<b>Product/Process Change Notice (PCN)</b>																										
<input type="checkbox"/> Major Change <input checked="" type="checkbox"/> Minor Change																										
<b>PCN Number:</b> PCN_FrqSPXO_20250225  <b>Affected Series:</b> WE-SPXO  <b>Affected Part Number:</b> See table below  <b>PCN Date:</b> 2024-11-25 <b>Effective Date:</b> 2025-02-25	<b>Change Category:</b> <input type="checkbox"/> Equipment/Location <input checked="" type="checkbox"/> General Data <input type="checkbox"/> Material <input type="checkbox"/> Process <input type="checkbox"/> Product Design <input type="checkbox"/> Shipping/Packaging <input type="checkbox"/> Supplier <input type="checkbox"/> Software																									
<b>Contact:</b> Product Management  <b>Phone:</b> +49 (0) 7942 - 945 5001  <b>Fax:</b> +49 (0) 7942 - 945 5179  <b>E-Mail:</b> pcn.eisos@we-online.com	<b>Datasheet Change:</b> <input checked="" type="checkbox"/> Yes <input type="checkbox"/> No  <b>Attachment:</b> <input type="checkbox"/> Yes <input checked="" type="checkbox"/> No																									
<b>DESCRIPTION OF CHANGE:</b> <p>Because of a database mismatch, Würth Elektronik eiSos will correct the RoHs status (

4. Correction of the Product Dimensions:

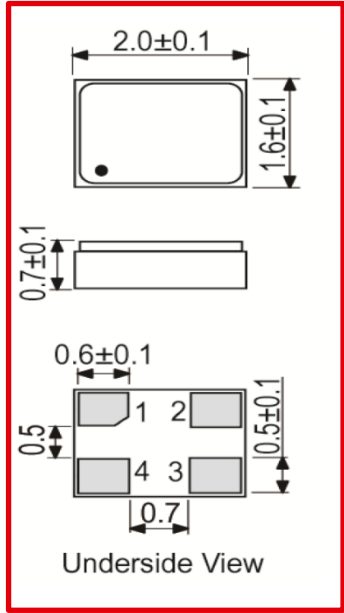
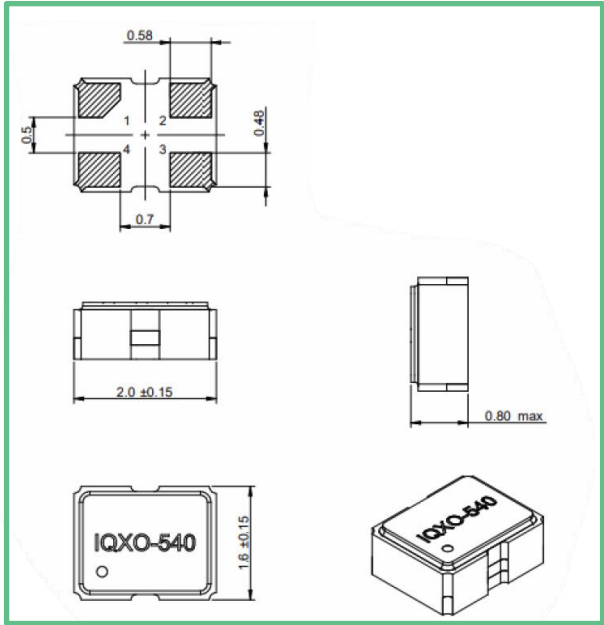
Before	After
Product Dimensions		
L	2.0 ± 0.1	2.0 ± 0.15
W	1.6 ± 0.1	1.6 ± 0.15
H	0.7 ± 0.1	0.80 max

5. Correction of the Solder Pad Layout:

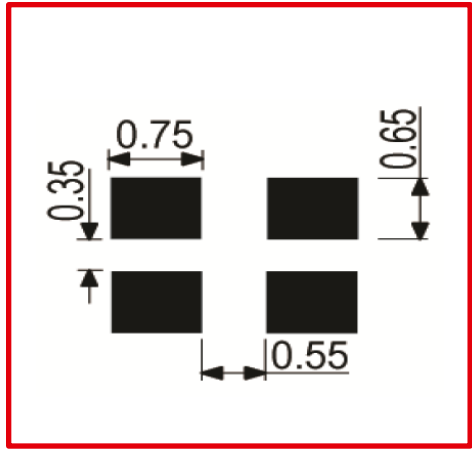
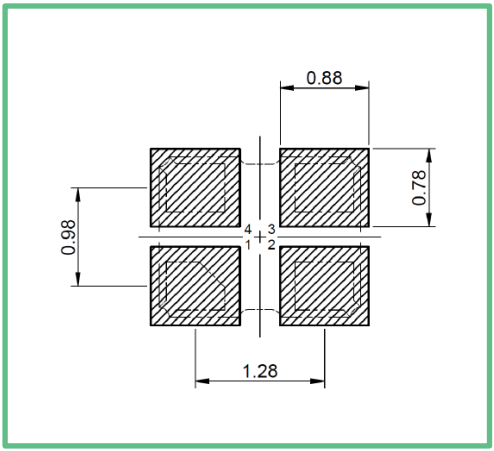
Before	After
Solder Pad Layout
